## Development Review Division

**TO:** Madeleine Reinke, Kimley-Horn and Associates, Inc.  
**FROM:** Cynthia Thye, Planner 1  
**DATE:** December 31, 2025  
**SUBJECT:** SP25-119: Lincoln Professional Park L2 - 7 Brews Coffee – Site Plan Review Comments 02

**2** TRASH ENCLOSURE PLAN  
3/8" = 1'-0"

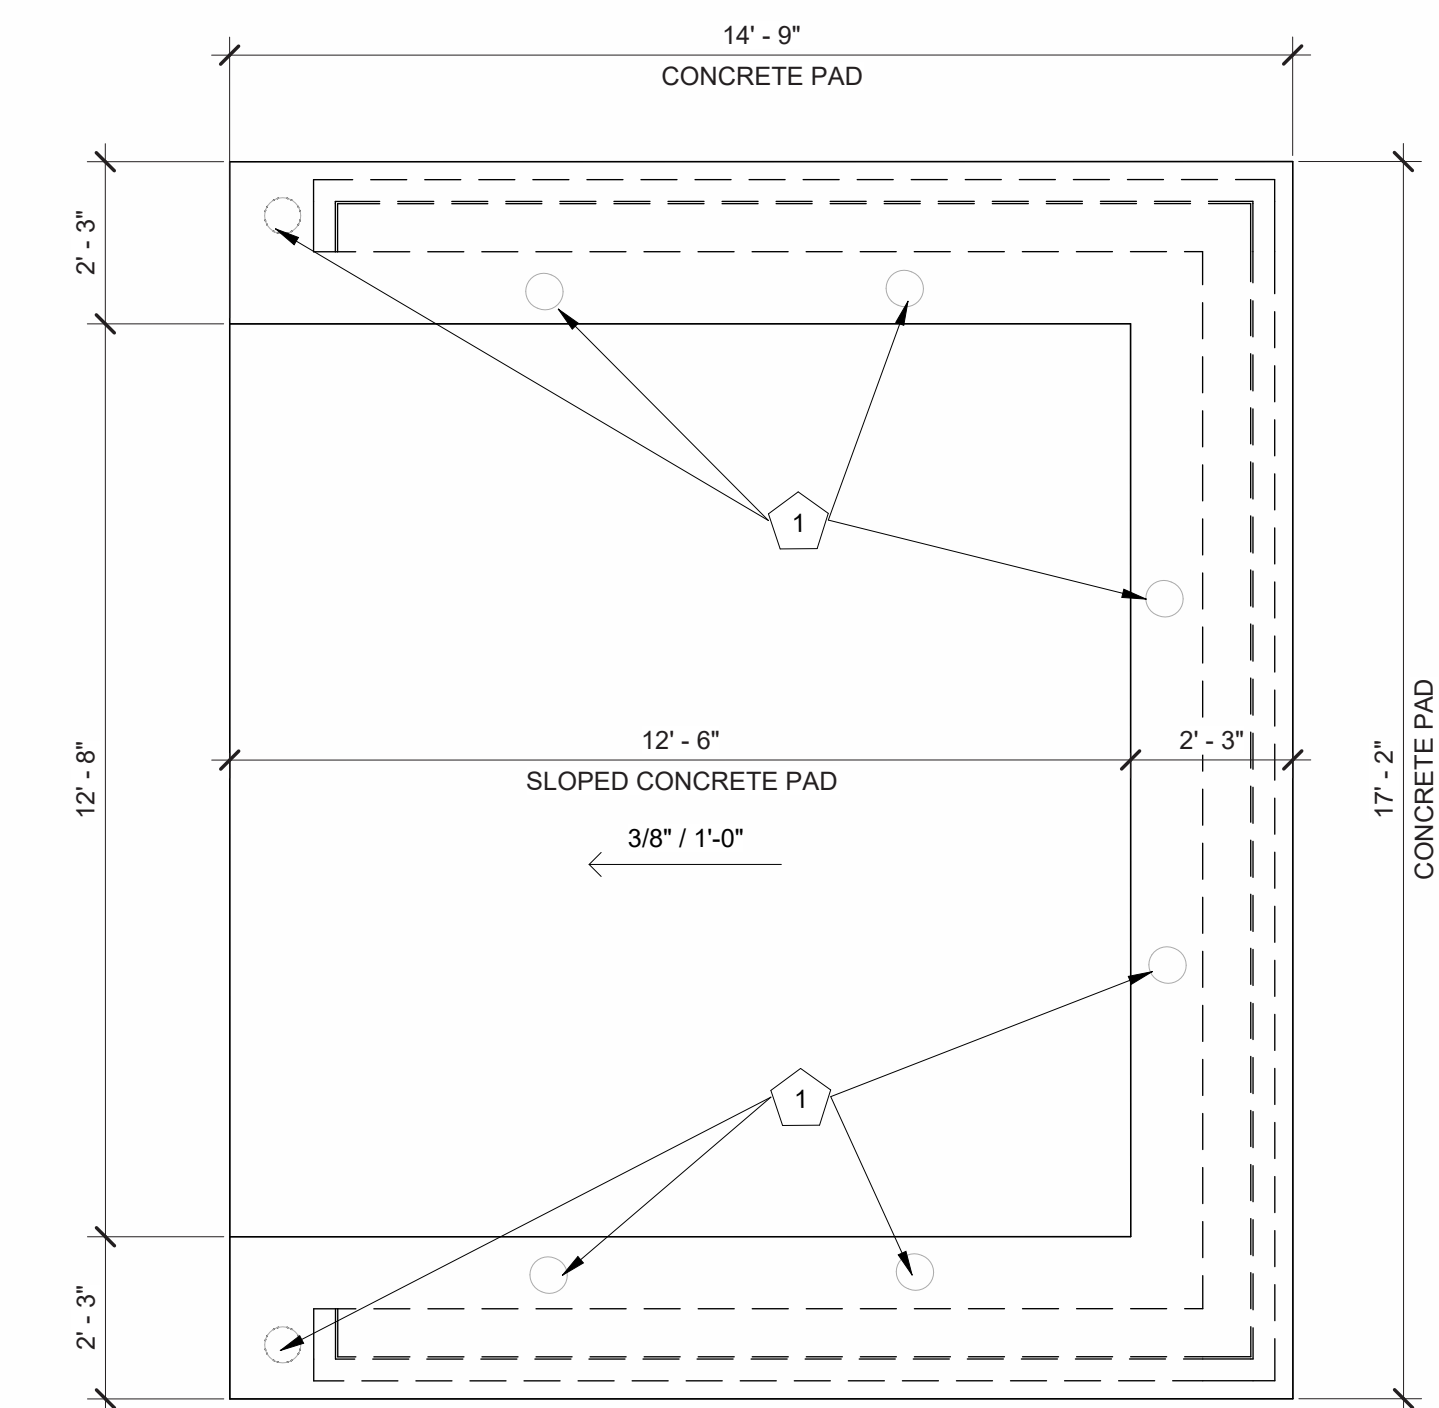
**14. Revise trash enclosure doors to be steel painted and color to match main building. Per LDO 13.08.130.**

Revised, see sheet A5.0.

FILE: XXX  
DRAWN BY: TFS  
CHECKED BY: AMF  
PROJ. NO.: 040022.014  
DRAWING NO.: **SE1.1**

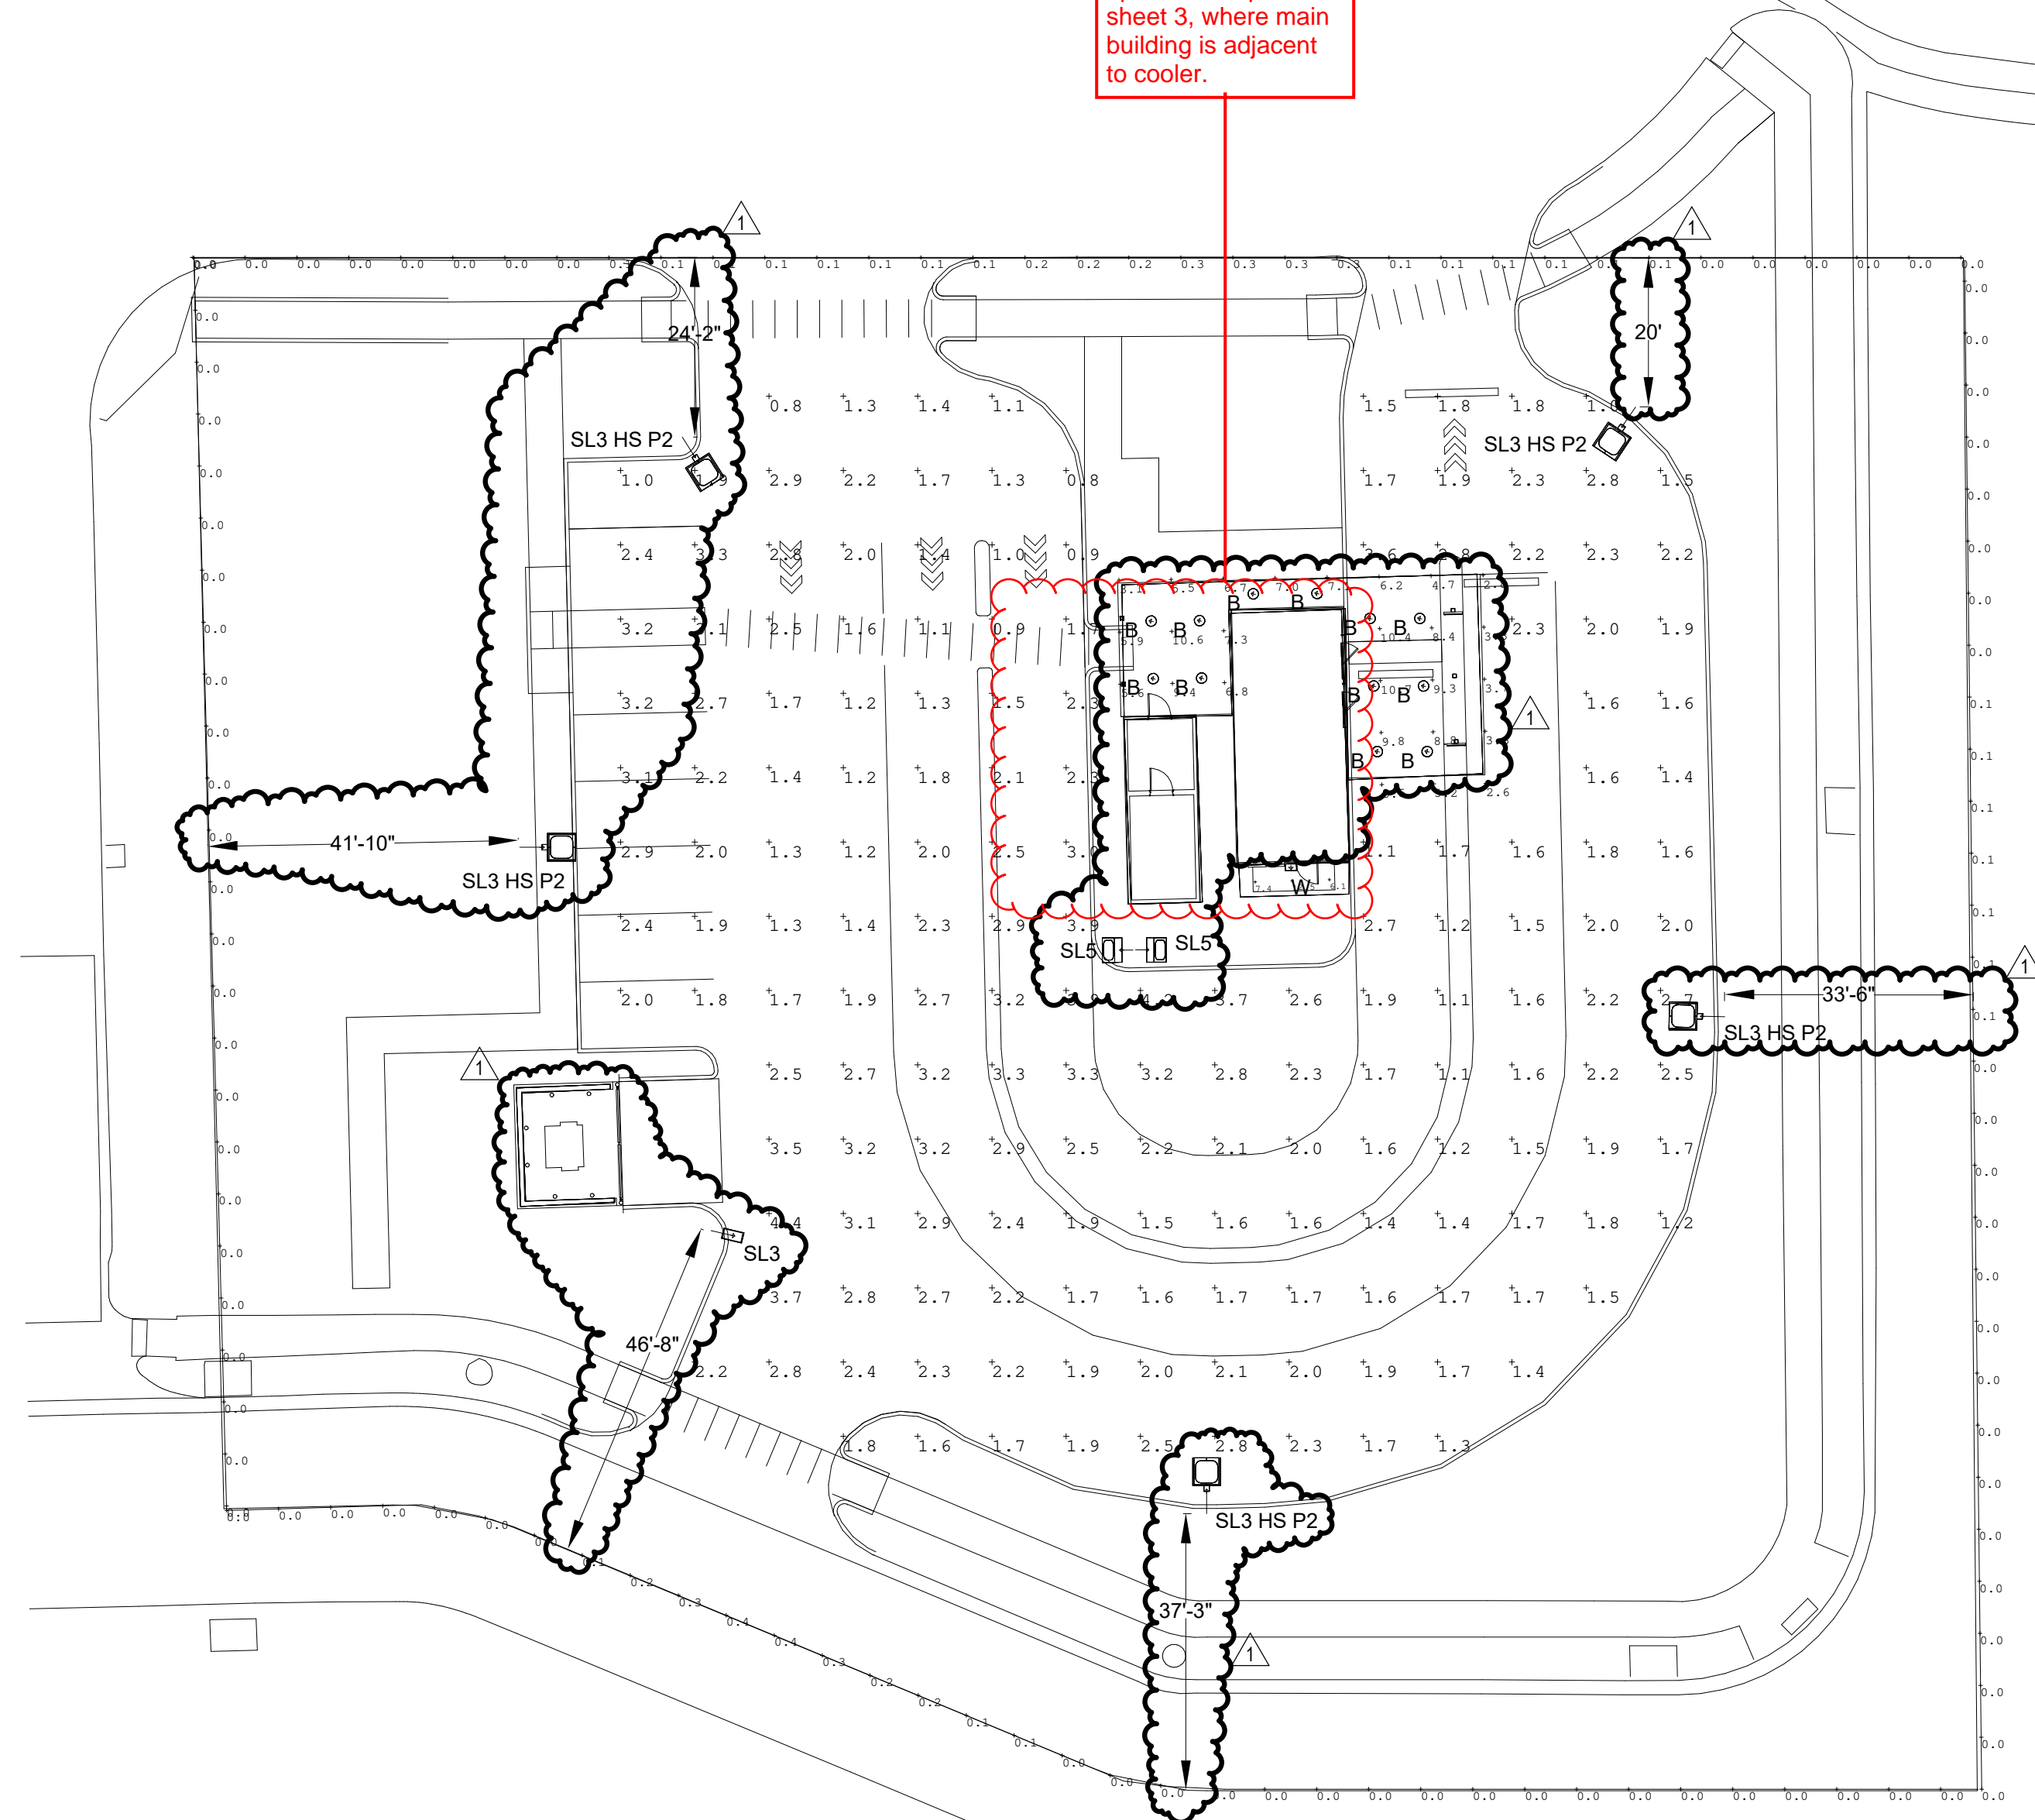
Add color of each fixture. Unless on ceiling of canopy need to be black or bronze.

Revise to match updated site plan sheet 3, where main building is adjacent to cooler.

**a. I/SE1.1 – SITE PHOTOMETRICS**  
i. Added (2) B fixtures in Rear Canopy per city comments.  
ii. Deleted (1) W fixture per civil plans updated.
